STANDARD FIELD SERVICE BULLETIN

FSB Number	CHRAEFSB2018-20
Author	Tony Bryan
Date	04/12/2018
Subject	Moto G6 Play - Intermittent Headset Audio (Connector Detect Pin)
Model Affected	XT1922-1/2/3/4/5/10 (ROW Models Only)
Level Of Repairs	Level 3

Figure 1.0 - Main-PCBA Part Numbers for Headset Jack Layout Change

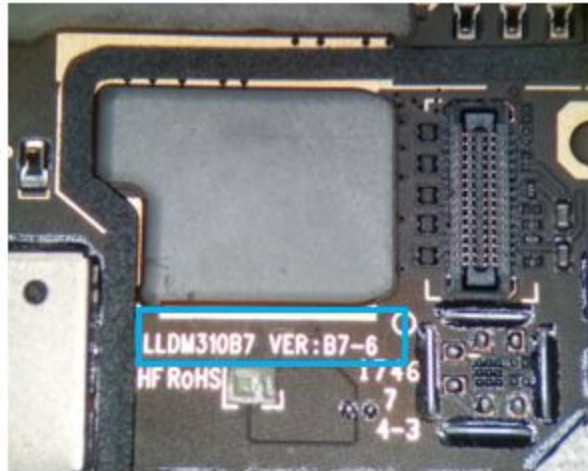
Long-Term: Motorola is implementing a further change to the Main-PCBA Layout to move the location of the detect line from the bottom pin to a side pin location. The Main-PCB part number will be updated to reflect this board layout change. Please see details below in Figure 1.0. This will be completed as a running change with a estimated implementation date of June 2018.

Main PCB: LLDM310 REV. B7-6 (shown)
Current Headset Jack Layout = LLDM310 REV. B8-6
Updated Headset Jack Layout= LLDM310 REV. B9-7

Issue Screen Method (Phone-Level)

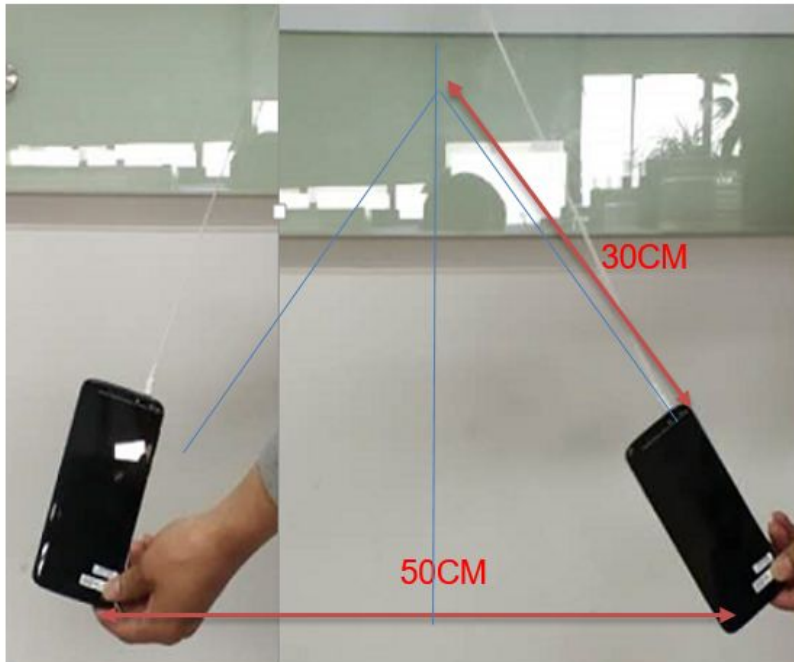
B. Service should implement the *Phone-Level Test Screen* method shown below, on Moto G6 Play (ROW) devices shipped prior to May 2018, regardless of complaint, as an outgoing quality measure.

1. Fix Wired Headset cable at 30cm position on a table
2. Fully insert plug into phone and start audio playback.
Confirm able to hear audio with phone at free position
3. Pull phone up slightly, about 25cm
4. Free-Swing phone between 50cm distance for 3s
5. Listen to confirm “no sound or interrupt sound” issue does not occur.
